ADDENDUM NO. 2

SUBJECT: Bid No. 0910-127 Project A Production Well 4 Remodel and Piping Modifications and Project B-Production Well 24 Phase II Upgrades

***BELOW GRADE POTABLE WATER
COMBINATION AIR VALVE DETAIL***

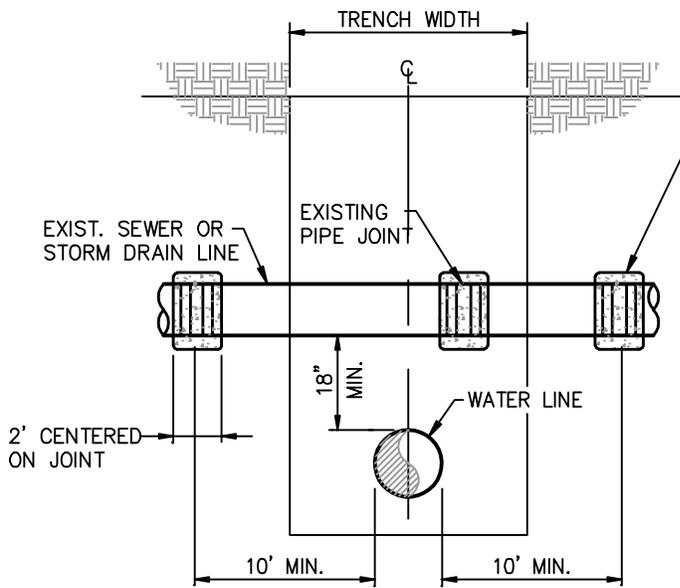
- E. **Sheet C7/22. Additional Details and Construction Notes;** The attached details C-3.1.2, the "NDEP Bureau of State Drinking Water Vertical Crossing Conflicts Summary" and the Air Release Detail are all now a part of sheet C7/22 and shall be utilized as required. The "FloodSafe" device shall be equipped with a 22 to 24 mesh per inch screen.

NO.	REVISION	DATE	STANDARD DETAIL FOR PUBLIC WORKS CONSTRUCTION	SECTION
			NEW WATER CROSSING EXISTING GRAVITY SANITARY SEWER OR STORM DRAIN	CARSON CITY
				DRAWING NO. C-3.1.2
				DATE 4/2009
APPROVED BY: _____

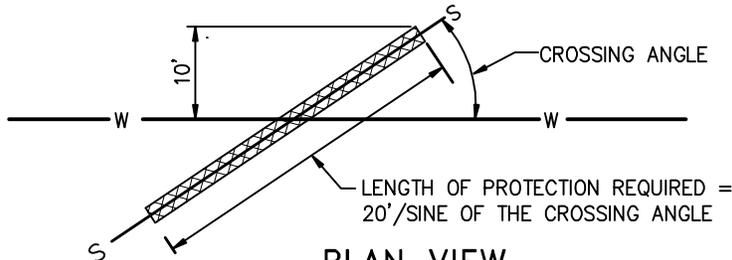
- E. **Sheet C8/17. Details and Construction Notes;** The attached detail C-3.1.2 and the "NDEP Bureau of State Drinking Water Vertical Crossing Conflicts Summary" are all now a part of sheet C8/17 and shall be utilized for the construction as required.

Sampling Taps

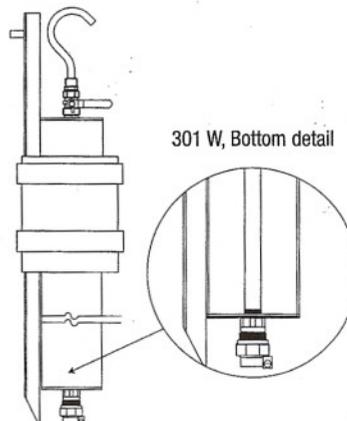
- B. **Sheet C4/17, Material List.** Change item #21 from a hose bib with vacuum breaker to a ½" MIP x plain Spout Brass Sampling Tap (see attached photo for example of approved unit).

- A. **Sheet C3/C22, Material List.** Change item #21 from a hose bib with vacuum breaker to a ½" MIP x plain Spout Sampling Tap (see attached photo for example of approved unit).
